# Hydrogeological and Hydrological Review

Proposed Coolnabacky Sub-station site Timahoe

Date: 16<sup>th</sup> February 2021

PROJECT NUMBER: IE2219		DOCUMENT REF: IE2219_Report_4840			
3.0	Issue	JK			16/02/2021
2.0	Issue	JK			11/01/2021
1.0	Draft	JK			21/12/2020
Revision	Purpose Description	Originated	Checked	Reviewed	Date

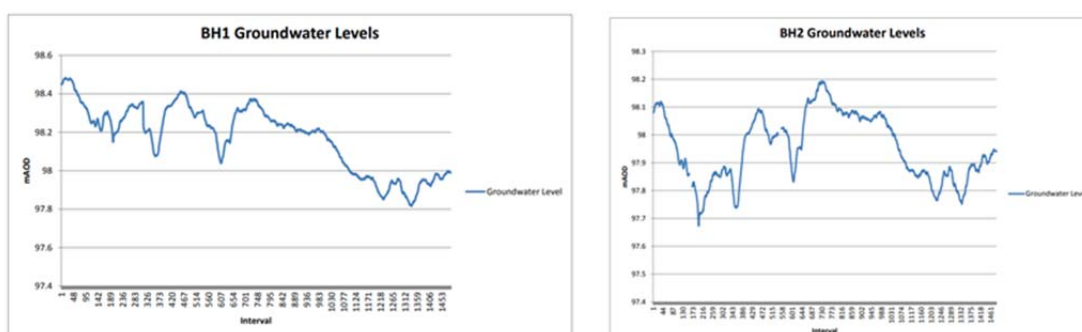
I consider that because the method of drilling can quickly case out water, the trial pits give a better view of shallow groundwater conditions as follows

I would suggest that these observations suggest some groundwater activity.
